## dsPIC33CH512MP508 Family Silicon Errata and Data Sheet Clarification

The dsPIC33CH512MP508 family devices that you have received conform functionally to the current Device Data Sheet (DS70005371D), except for the anomalies described in this document.

The silicon issues discussed in the following pages are for silicon revisions with the Device and Revision IDs listed in [Table 1](#). The silicon issues are summarized in [Table 2](#).

**FIGURE 1-1: I/O RAMP**

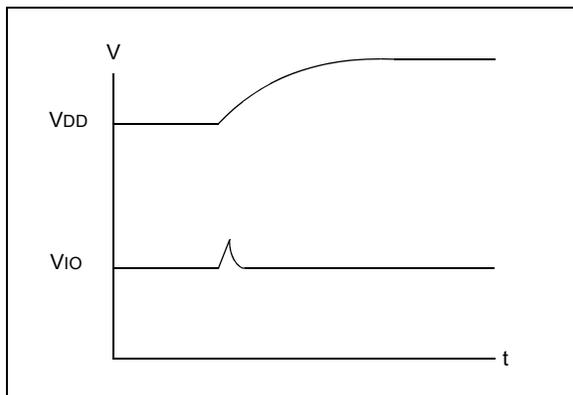
During a fast device power-up, when the VDD ramp is less than 4 mS, the I/O pins may drive up to 100  $\mu$ A current for a duration of up to 10  $\mu$ S (Figure 1-1).

1. Slow down the VDD ramp time (greater than 4 mS for VDD to ramp 0V to 3.3V).
2. Ensure the circuitry that is connected to the pins can endure this pulse.

Example applications affected may include complementary power switches, where a transient current shoot-through might occur. High-voltage applications with complementary switches should power the high-voltage 200  $\mu$ Sec later than powering the dsPIC<sup>®</sup> device to avoid the current shoot-through. This behavior is specific to each device and not affected by aging.

**FIGURE 2-2: SUGGESTED PLACEMENT OF THE OSCILLATOR CIRCUIT**

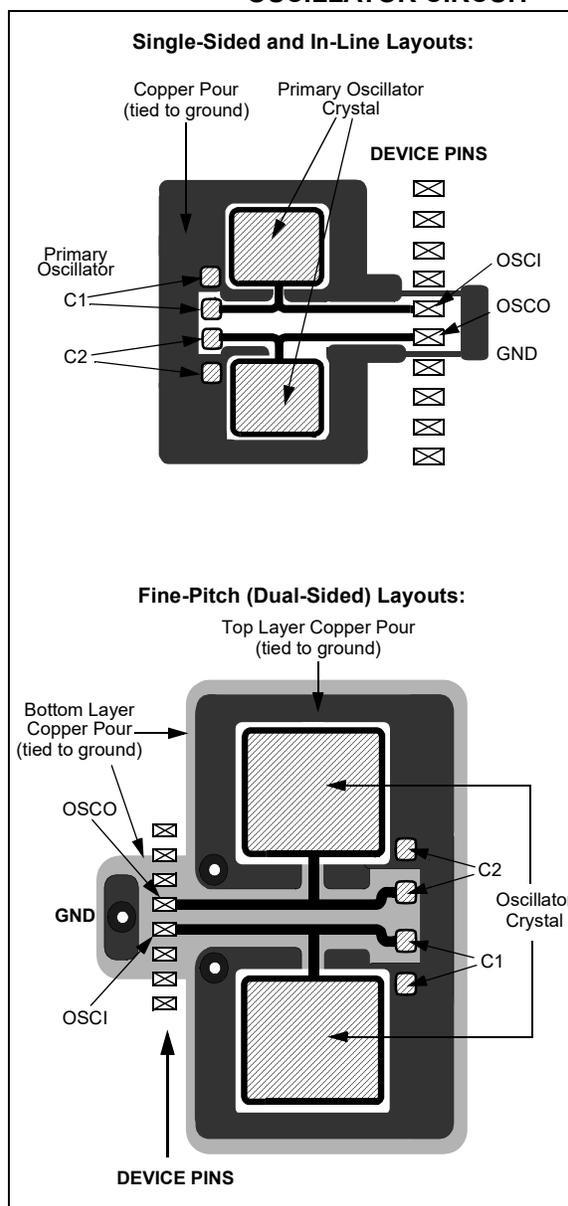
Additional information is added to [Section 2.5 “External Oscillator Pins”](#) and [Section 2.6 “External Oscillator Layout Guidance”](#) is added.

### 2.6 External Oscillator Layout Guidance

Use best practices during PCB layout to ensure robust start-up and operation. The oscillator circuit should be placed on the same side of the board as the device. Also, place the oscillator circuit close to the respective oscillator pins, not exceeding one-half inch (12 mm) distance between them. The load capacitors should be placed next to the oscillator itself, on the same side of the board. Use a grounded copper pour around the oscillator circuit to isolate it from surrounding circuits. The grounded copper pour should be routed directly to the MCU ground. Do not run any signal traces or power traces inside the ground pour. If using a two-sided board, avoid any traces on the other side of the board where the crystal is placed. Suggested layouts are shown in [Figure 2-2](#). With fine-pitch packages, it is not always possible to completely surround the pins and components. A suit-

able solution is to tie the broken guard sections to a mirrored ground layer. In all cases, the guard trace(s) must be returned to ground.
